Heritage Advisory Committee  
May 22, 2013

**Case H00373: Substantial Alteration to 4 York Redoubt Crescent, Fergusons Cove (Stella Maris Church), a registered municipal heritage property**

SOUTH ELEVATION

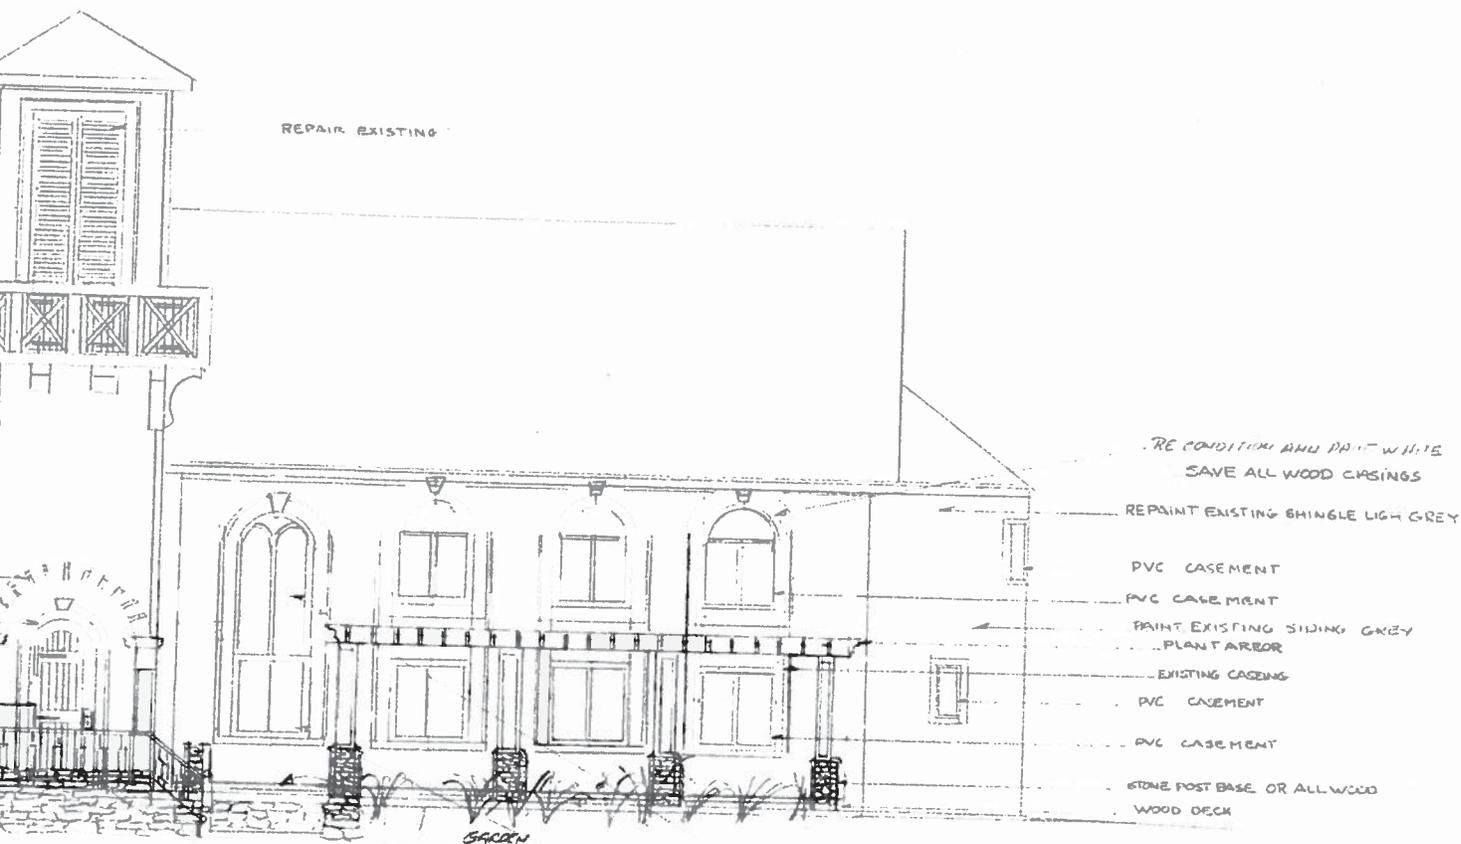
- **Historic Character:** Many character-defining elements of the property will be retained and preserved in this rehabilitation project. However, the deteriorated condition of the building and the transition of uses involve the removal of numerous historic materials and alteration of characteristic features. Where this is the case, design responses retain key materials and emulate features that characterize the heritage property. The top half of the harbour-side tower was inspected by an HRM Building Official and determined to be in poor structural condition. The property owner will make every effort to preserve the harbour-side tower in its entirety. However, they would like the option of removing the top half of the tower if it is deemed unsafe by a structural engineer and becomes an

insurance liability. To provide this option, this proposal must be understood to include the preservation of one tower in its entirety and only half of the harbour-side tower. On the front façade, all framed openings will be preserved. Three of the Classic Revival style wooden windows will be replaced with vinyl in like appearance. The opening holding the copper alcove will be converted to a patio doorway while the top portion of the copper alcove will be cut and retained in place as a heritage feature. A new second storey will be contained entirely within the existing building envelope by installing an internal platform. As a result, three of the tall window openings along one side will be divided into two separate windows while emulating their original proportions within their original frames.

YORK REDOUBT CR. ELEVATION

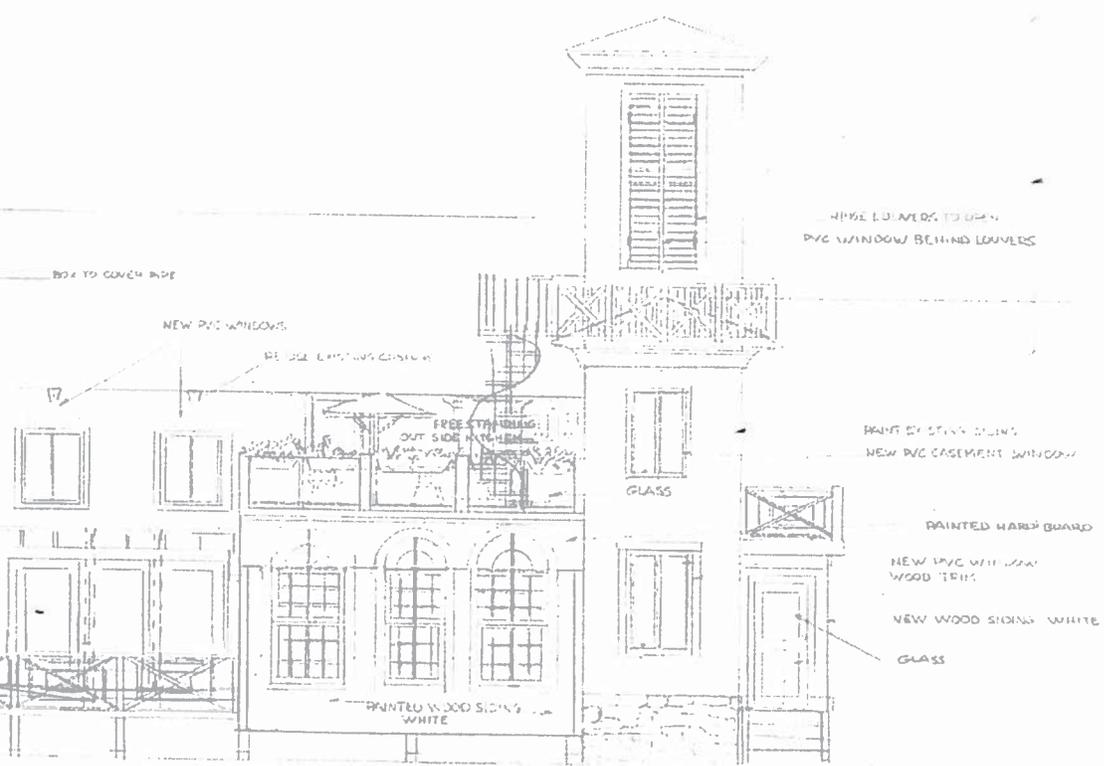
- **New Additions: Differentiated and Compatible with Massing, Size, and Scale:** This proposal consists of two new additions: a harbour-side sunroom and a front veranda. Both the sunroom and veranda additions are compatible with the heritage building in terms of their massing, size, and scale. They will be clearly distinguished as modern structures clad with a cement board material in a different colour from the heritage building. The harbour-side sunroom addition and the adjacent sliding glass door will replace the historic tall windows on this side of the building.

- **New Additions: Essential Form and Integrity Remains Unimpaired:** The heavy timber construction will be largely preserved within the existing building frame. New openings into the sunroom and veranda additions will be between existing timber posts. The only alteration to the heavy timber construction is on the harbour side where two timber posts will be cut and reframed for the sliding glass door. An HRM Building Official has confirmed that the new second storey platform will provide a structural benefit in stabilizing the timber frame construction. All three additions can be removed in the future and the essential form and integrity of the heritage building and its environment would be unimpaired. Furthermore, all original windows will be salvaged by reincorporating them in the sunroom addition, interior walls, or by storing them within the building.
